STAFF SUMMARY REPORT (Jack Gregg)
MEETING DATE: April 12, 2017

SUBJECT: **The Wine Group, LLC, Concannon Winery, Livermore Valley, Alameda County** – Issuance of Waste Discharge Requirements

REVISED TENTATIVE ORDER No. R2-2017-00XX

**THE WINE GROUP, LLC
CONCANNON WINERY WASTEWATER MANAGEMENT SYSTEMS
LIVERMORE VALLEY, ALAMEDA COUNTY**

PROCESS FLOW DIAGRAM
 SCALE: NOT TO SCALE
 DATE: 2016-08-19
 DRAWN BY: SEA
 JOB #: 2016-005
 SHEET: M-0.03
 01 OF 01 SHEETS

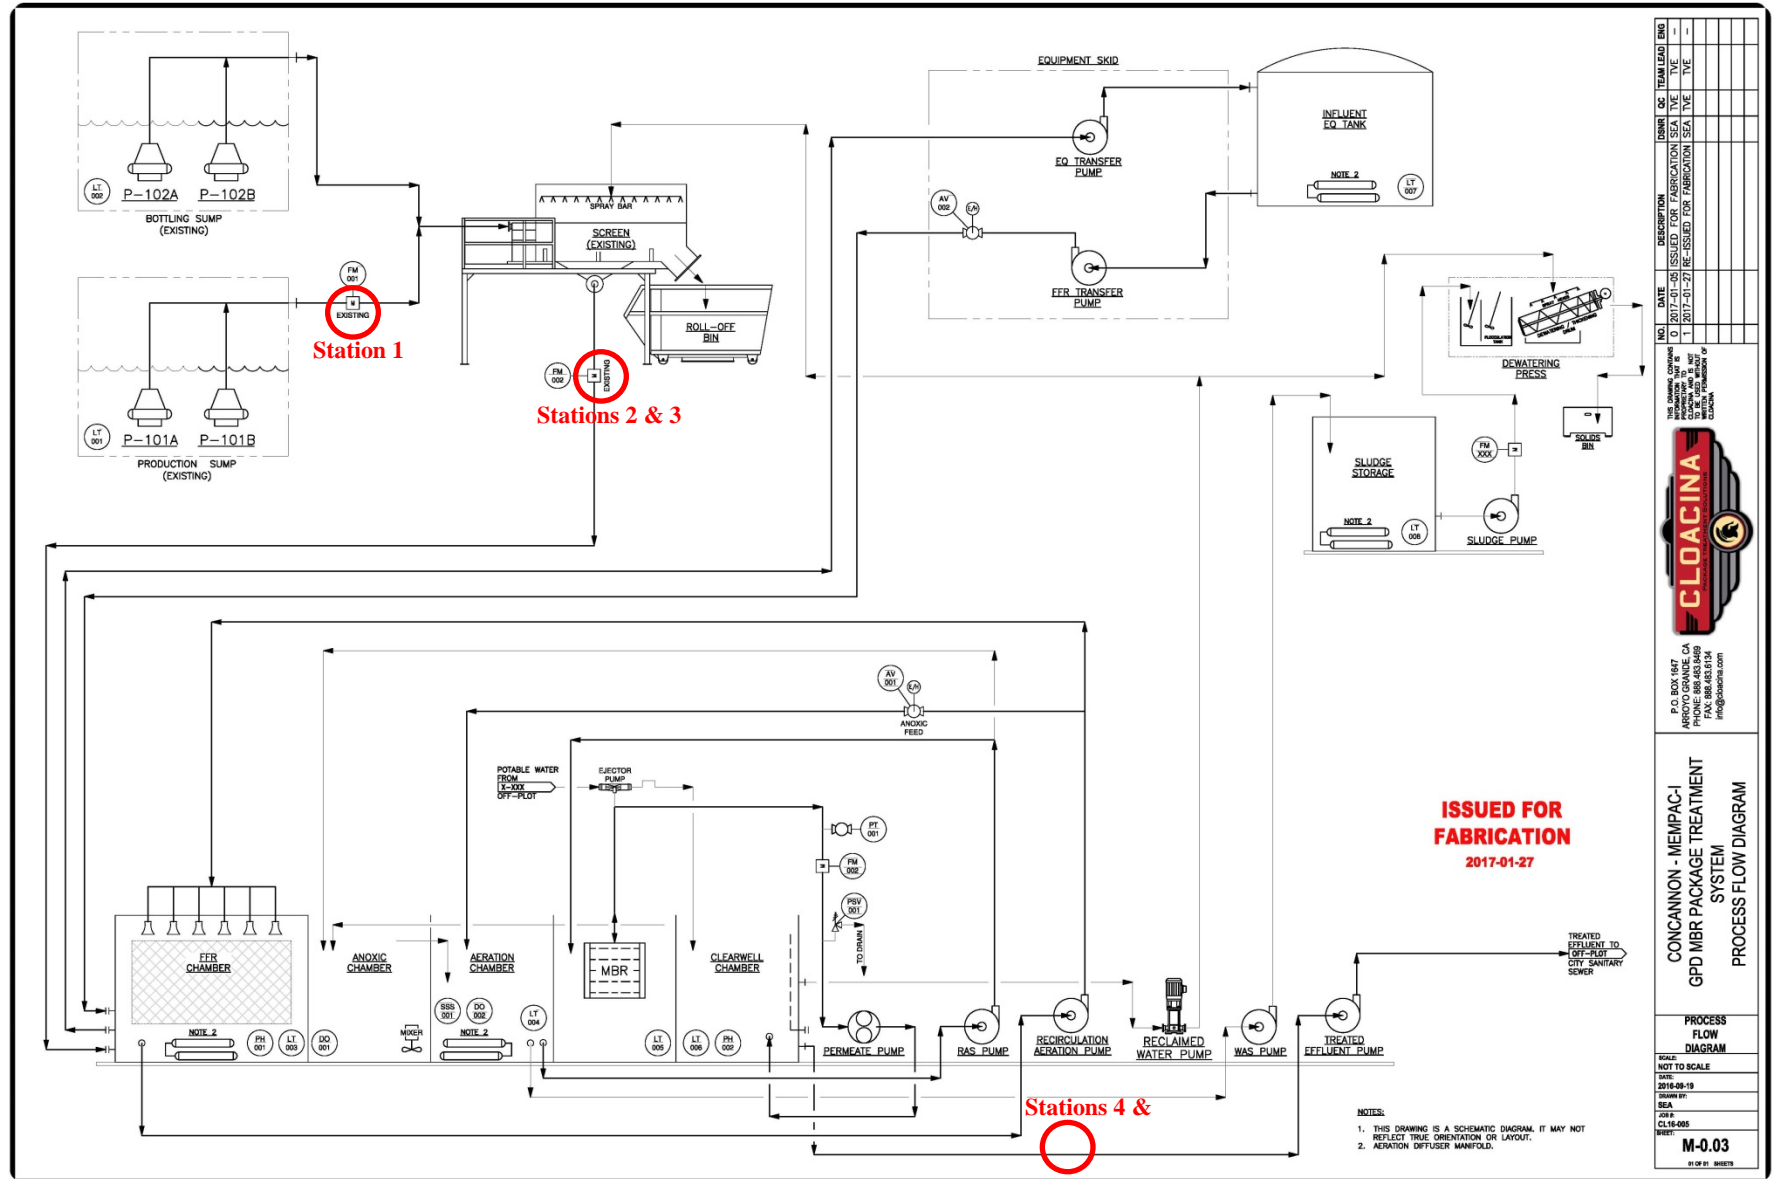
Included below, updated Process Flow Diagram (PFD) intended to replace Figure 5 on page 28 of the draft WDR:

The Wine Group Comment 17 – Replace Figure 5, page 28:

Included below, updated Process Flow Diagram (PFD) intended to replace Figure 5 on page 28 of the draft WDR:

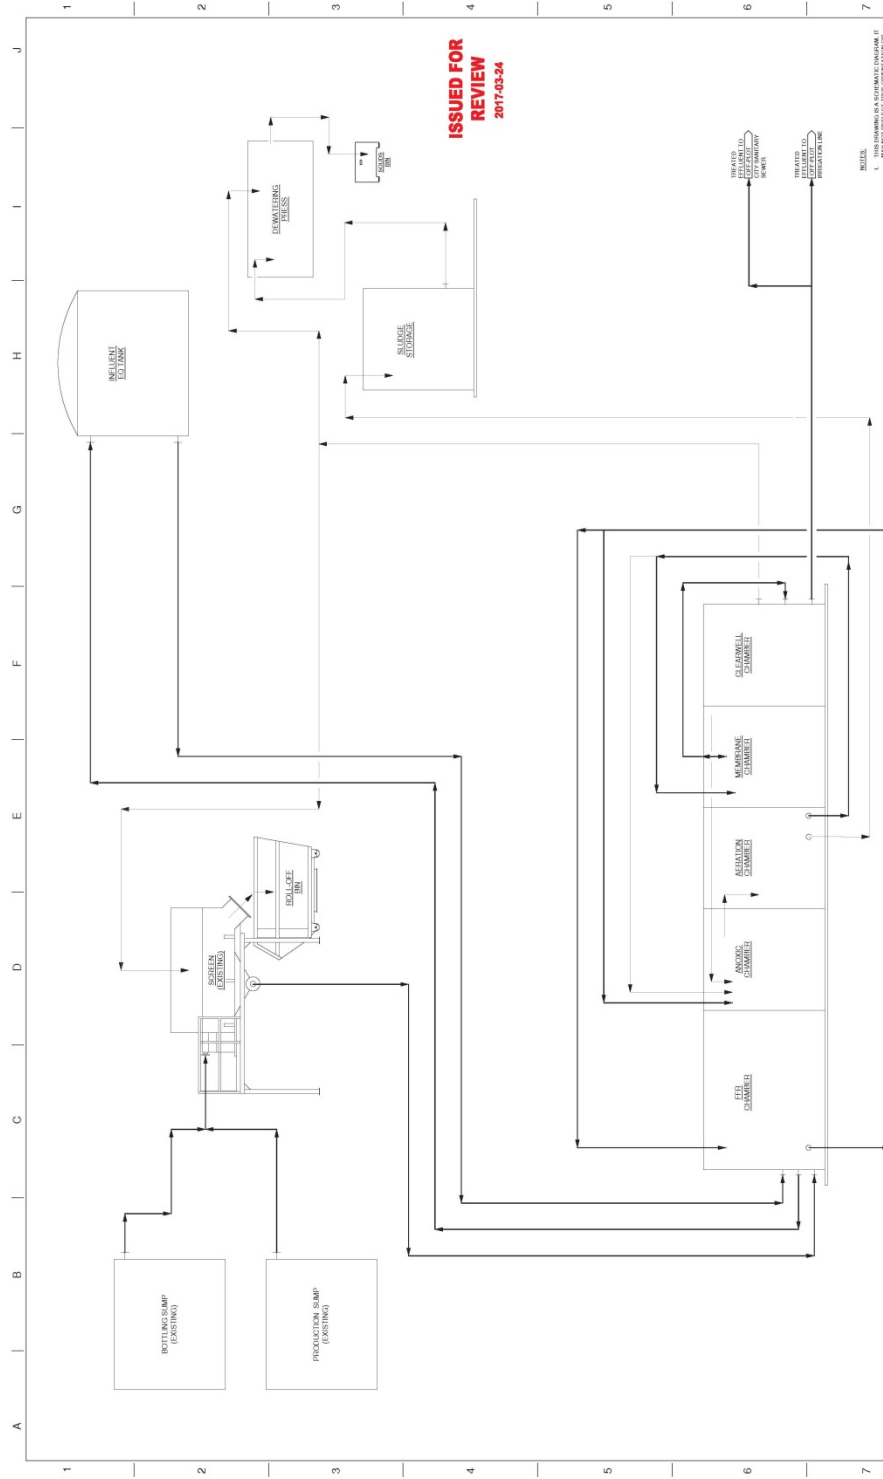
c. Rotary Screen. The rotary screen removes solids larger than ~~.020”~~~~2-millimeter~~ when wastewater passes through a 4-foot-diameter, stainless steel, elevated rotary screen.
